**REPORT OF THE CORPORATE DIRECTOR FOR POLICY, PLANNING AND
CORPORATE**

**STRATEGIC PLANNING OBSERVATIONS ON A SINGLE WIND TURBINE,
ON LAND SOUTH WEST OF WHATTON STUD, MANOR LANE, WHATTON**

PLANNING APPLICATION NO. 2013/01730/FUL

LOCATION: Whatton Manor Stud, Whatton in the Vale
PROPOSAL: Erection of single 77 metre wind turbine and other ancillary development

Appendix 1 – Site Location Plan

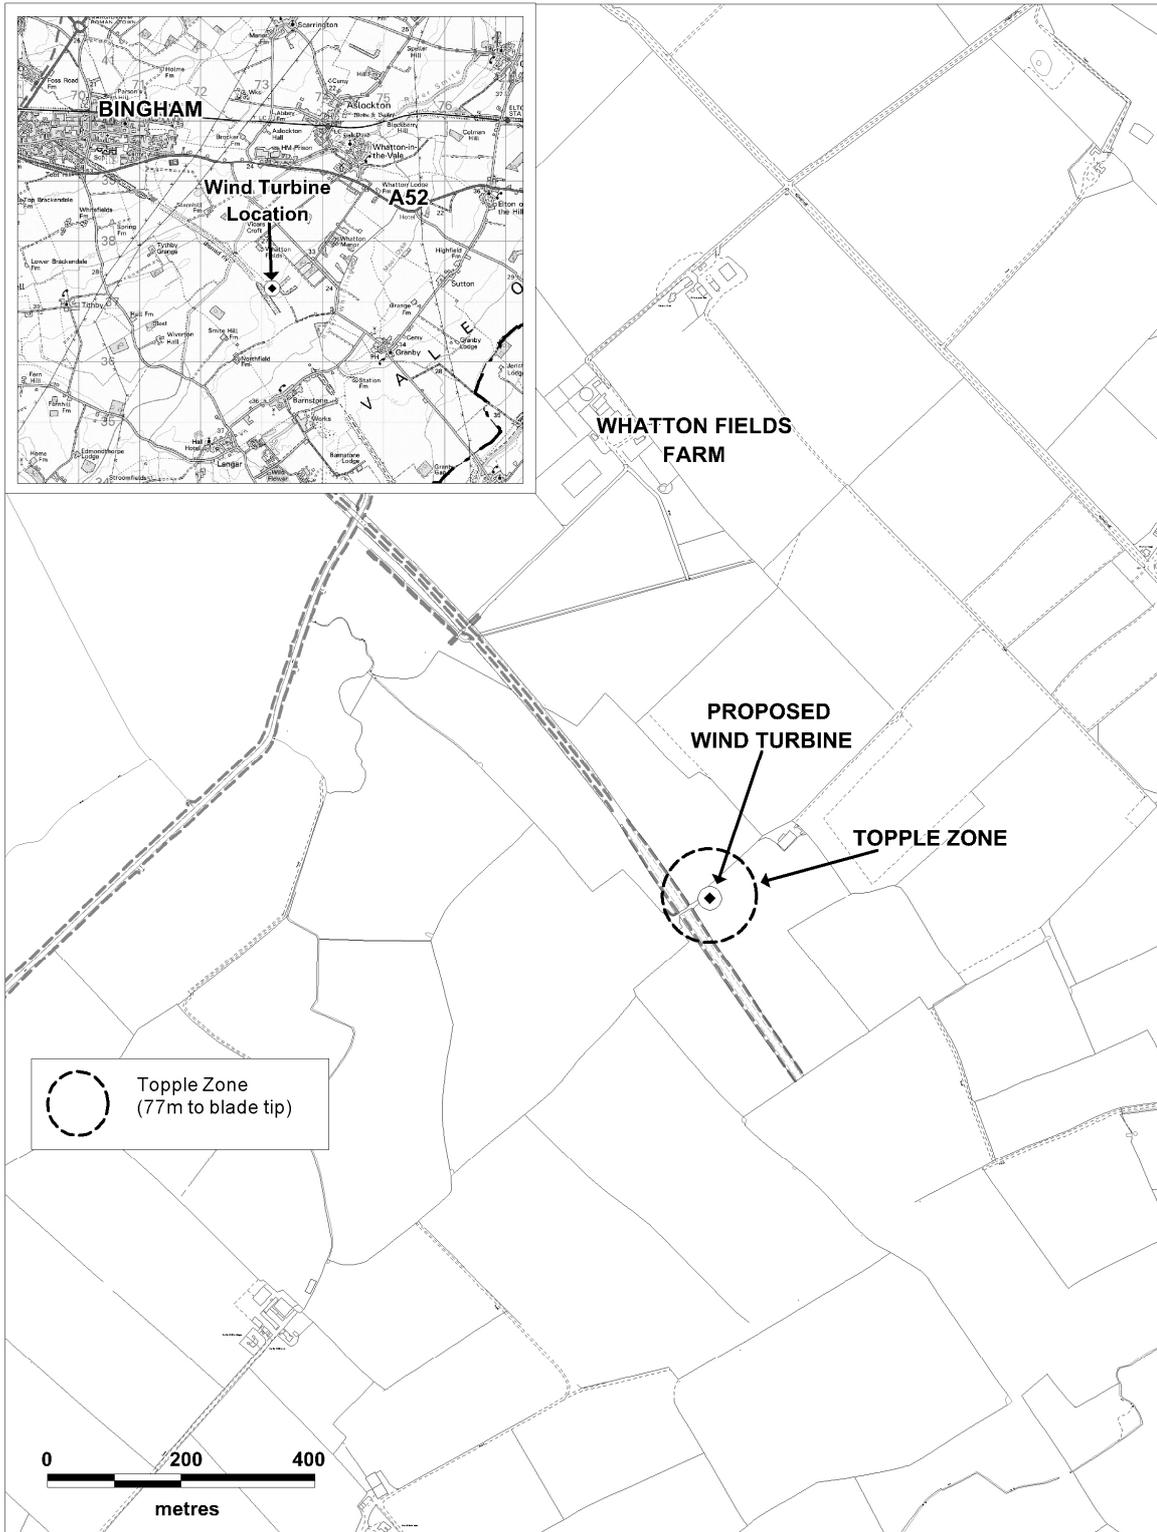
1. Footpath no 14 Whatton which leads into Footpath no 17 Langar cum Barnstone. At its closest point to the turbine is just outside the tip height plus 10% distance and therefore is of limited concern.
2. Bridleway no 1 Langar cum Barnstone is some 550m away.
3. There is a claimed bridleway which is 250m away. This has not reached its full determination yet so may or may not be added to the map through a Public Inquiry. However it is outside of the 200m recommended by the British Horse Society so is of limited concern. The first part of this claimed route is used in the access to the site but as this is track already it is unlikely to be left in a damaged state, and there is no public access on it yet (if ever).

The only real concern is the access to the site which will cross the footpath just before the barn near to the turbine location. The applicant/contractors will need to ensure that the public are safe to still use the footpath while the construction works are being undertaken. This may include appropriate signage for both the public and the construction staff to be aware of each other and that no obstructions are placed across the path to hinder the walker crossing the track.

Appendix 5 – Landscape Viewpoint Plan

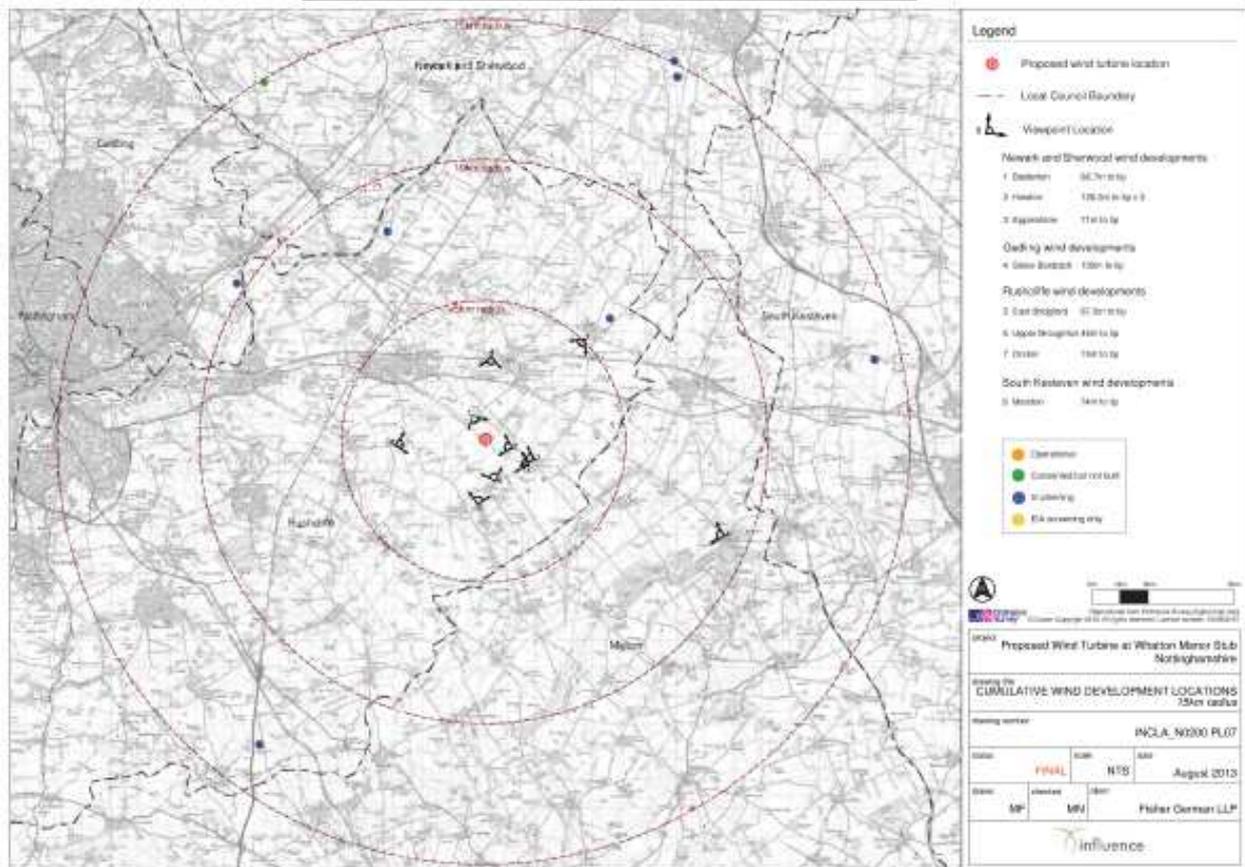
Viewpoints – The applicant should reconsider the degree of significance assessed for Viewpoint 2

Include additional viewpoints from adjacent high sensitivity residential receptors (2 no) and closest Bridleway (BW1 Langar cum Barnstone)

Viewpoints – these were determined by the consultants themselves, they were not agreed with RBC in advance as would be best practice. Ten viewpoints were assessed in June 2013 when trees were in full leaf, it would have been preferable to carry out this assessment after leaf fall to represent the worst case scenario in terms of visual impact. Also views from some of the closer residential receptors, agreed in Table 1 as of high sensitivity, have not been assessed, we would suggest that viewpoints from the following properties are also included, and from the closest Bridleway.

- View from Northfield Farm to the south west
- View from Whatton Manor to the north east
- View from Bridleway (Langar cum Barnstone BW1) to the south

Viewpoint 2 – From PROW public footpath at the junction of Granby Lane and Granby Hill, looking west towards to the application site

NCC are not in agreement with the applicant that the magnitude of change is low adverse at completion, it is at least medium adverse which would mean that the assessment of Minor/Moderate adverse visual effect is under estimated.

Viewpoint 2 - 5 and 10 Minor/moderate operational stage - NCC - viewpoint 2 impact should be reconsidered
